# Service Bulletin

Bulletin No. 2006-06

## Ground Strap Kit - 200/225/250/275 Verado

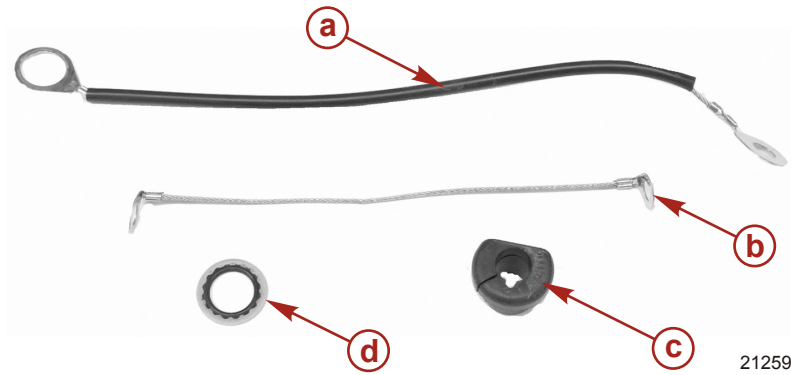
Mercury Marine has released a new Ground Strap Kit (part number 899712A01) that can be used on the above listed outboards. This new kit will contain ground straps and related components to complete a continuity (ground) circuit between the lower unit and the remainder of the outboard. Completing this circuit will allow a partially submerged lower unit with the lower unit anodes out of the water to utilize the corrosion control anodes attached to the trim manifold and/or the pedestal splash plate. This upgrade is particularly beneficial to customers with outboards at risk for corrosion damage (because they use shore power or moor their boats in saltwater or freshwater where stray current is present), and are unable to tilt their outboards fully out of the water.

Install ground strap kit (part number 899712A01) on any of the above listed outboards as outlined in the kit supplied installation instructions.
